Backfeed v264

145.2.4 PSE PI

145.2.10.3a Reflected voltage

Figure 145-27a — Detection signature requirements connection configurations

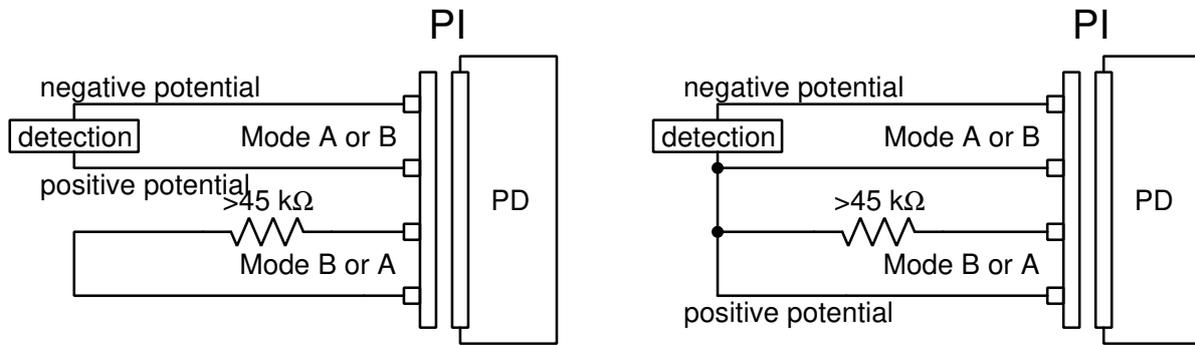
While a PD presents a valid detection signature on a given Mode, that detection signature shall be valid when presented under each of the following conditions (see Figure 145-27a):

- with any resistance greater than 45 k Ω across the other Mode
- with any resistance greater than 45 k Ω across the other Mode and one pair connected to the positive potential of the given Mode

Add new Figure 145–27a as follows:

Figure 145–29a — Reflected voltage requirements

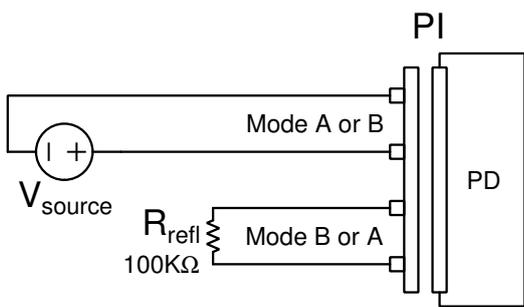
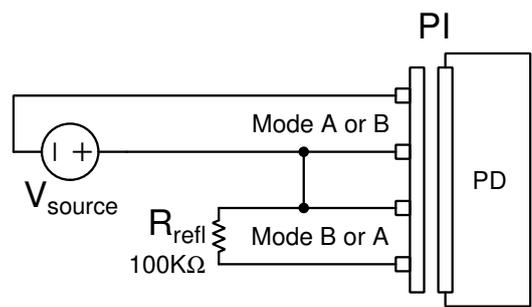
145.3.8.8 ~~Backfeed~~ Reflected voltage

Replace the contents of 145.3.8.8 as follows:

For a single-signature PD, when any voltage in the range of 0 V to $V_{Port_PD-2P\ max}$ is applied per any of the valid 2-pair configurations, defined in Table 145-20, that have only a single pair connected to positive V_{PSE} (see Figure 145-29a), the voltage on the Mode not connected to the voltage source, with a 100 k Ω resistor connected across that Mode, shall not exceed V_{refl} as defined in Table 145-29.

For a dual-signature PD, when any voltage in the range of 0 V to $V_{Port_PD-2P\ max}$ is applied per any of the valid 2-pair configurations, defined in Table 145-20, including those with two pairs connected to positive V_{PSE} (see Figure 145-29a), the voltage on the Mode with at least one pair not connected to the voltage source, with a 100 k Ω resistor connected across that Mode, shall not exceed V_{refl} as defined in Table 145-29.
